Attachment 1
IN 92-67
September 10, 1992
Page 1 of 6

SHEARON HARRIS NUCLEAR POWER PLANT UNIT 1
DOCKET NO. 50-400/LICENSE NO. NPF-63
10CFR PART 21 REPORT
MAIN FEEDWATER PREHEATER BYPASS VALVES

POTENTIAL FAILURE OF
MAIN FEEDWATER
PREHEATER BYPASS VALVES

Shearon Harris Nuclear Power Plant, 10CFR21 reportable deficiency. Potential failure of Main Feedwater Preheater Bypass Isolation Valves.

RALPH A. MILLER COMPANY PITTSBURGH, PA. 15234	
AIR CIRCUIT & WIRING DIAGRAM	
DATE: <u>JL 10-2-80</u>	SCALE: _____
BY: <u>D.H. 10-23-80</u>	APP: <u>D.B. 10-24-80</u>
12 SA-A029 SHEET REV. 1 OF 5

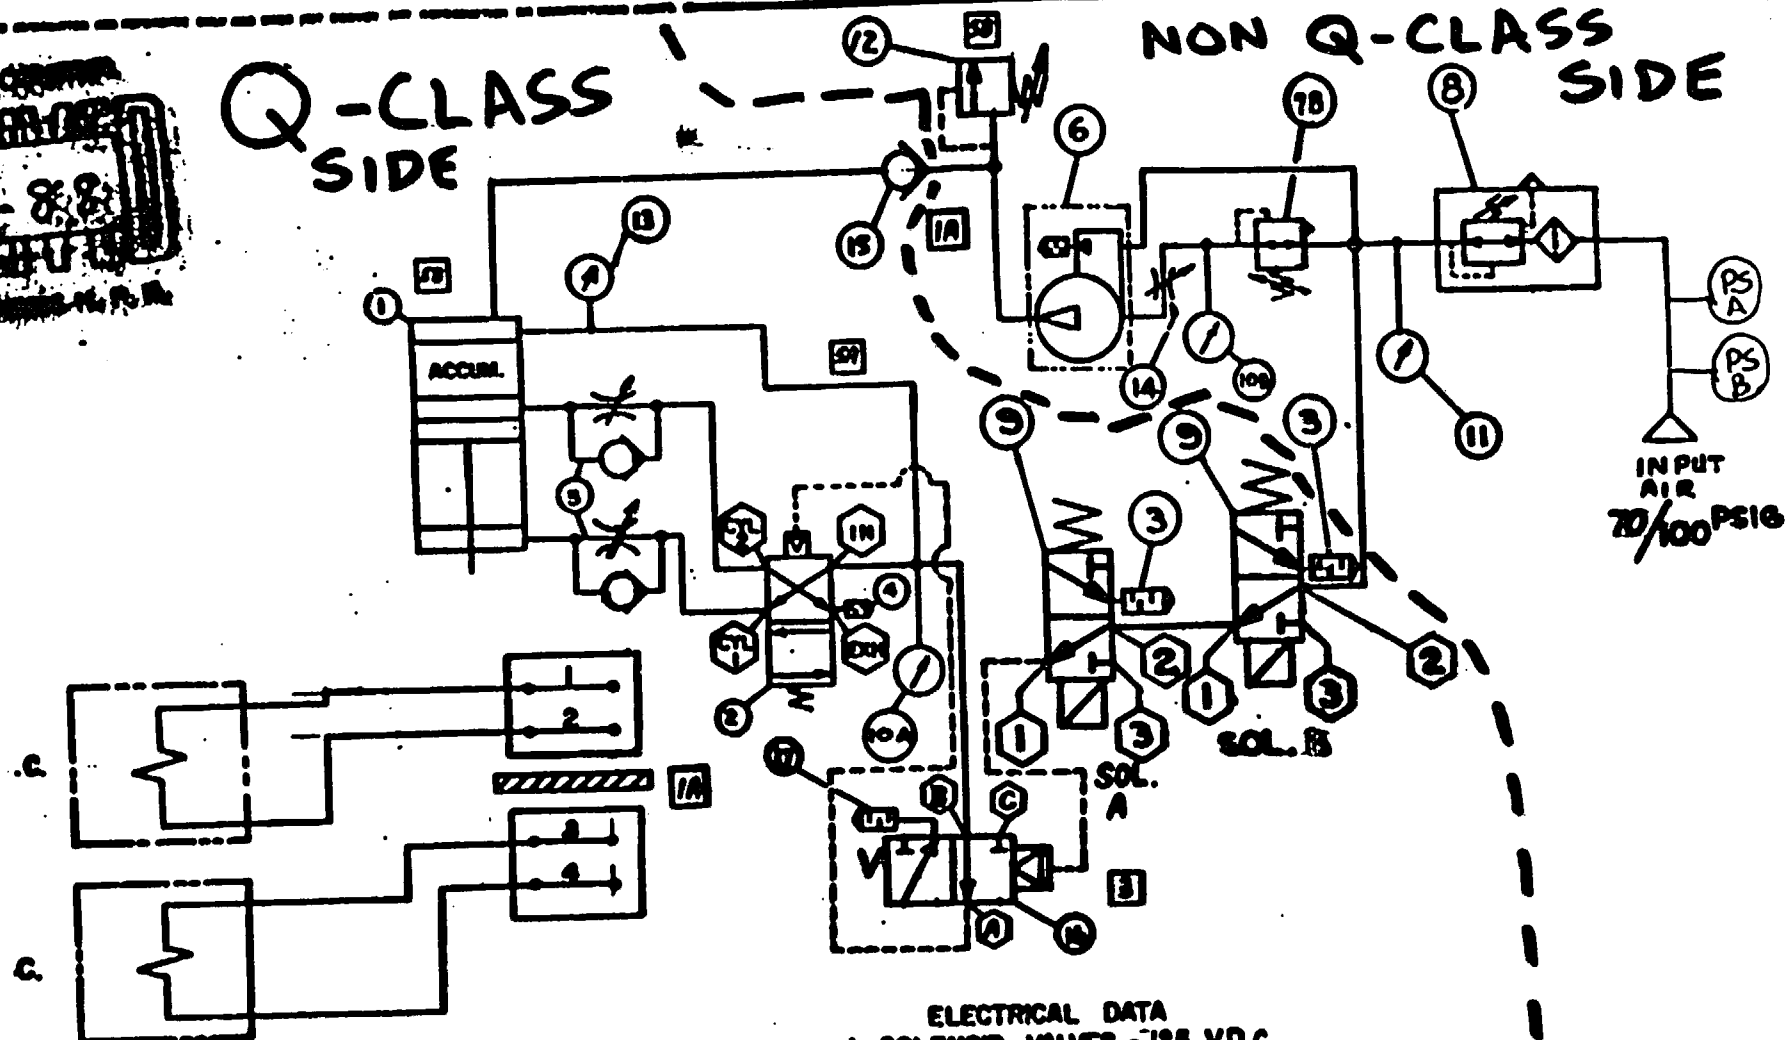
A potential failure mechanism existed where the failure of a non-Q component could result in the inability of a Q-class component to perform as designed. Specifically, a postulated failure of the air pump (item 6 on attached drawing), could cause a situation where normal leakage of the accumulator (item 1) from its normal 150 psig pressure would go undetected by redundant pressure switches (PS A and B). These switches provide the valves an auto close signal when pressure drops to 66 psig in the input air header.

The valves are containment isolation valves and are required to close within 10 seconds of a feedwater isolation signal. If accumulator pressure drops from its normal 150 psig to below 122 psig, it may not close within the required time. If accumulator pressure drops to approximately 20 psig, there may not be sufficient force to reposition the valve and maintain it closed against maximum differential pressure.

Upon discovery of this condition on January 7, 1992 a two hour surveillance interval was commenced to verify the actuators' components were functioning properly and the accumulators were fully pressurized. On January 12, 1992 a plant change request (PCR 06158) was implemented which replaced the non-Q components with suitable components. Testing was completed satisfactorily and the two hour surveillance interval was suspended.
